Report: TAB Report
Function: Test, Adjust, & Balance
Date: 01/30/2026
Completed By: National TAB

PROJECT
01-26-26 WAWA #7219 LIMA, OH

Project: 01-26-26 WAWA #7219 LIMA, OH

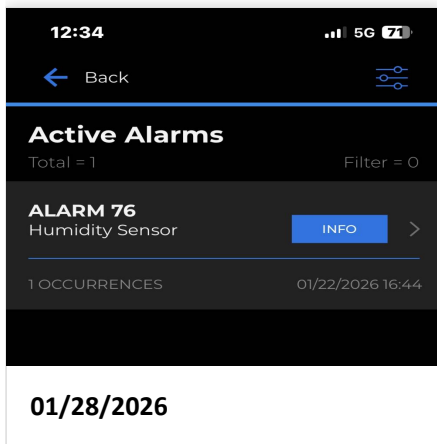
Issue Name : RTU-1 RETURN DUCTWORK
Description : Return grill 1-3 disconnected(Resolved). | Return grill 1-2 not ducted. | Return grill 1-1 is not present. | TAB cannot be completed until resolved.
Created By : National TAB **Assigned To :** National TAB - Noah Stafford
Status : Open
Priority : Urgent **Asset Tag :**
Originated Date : 01/27/2026 - Noah Stafford - National TAB
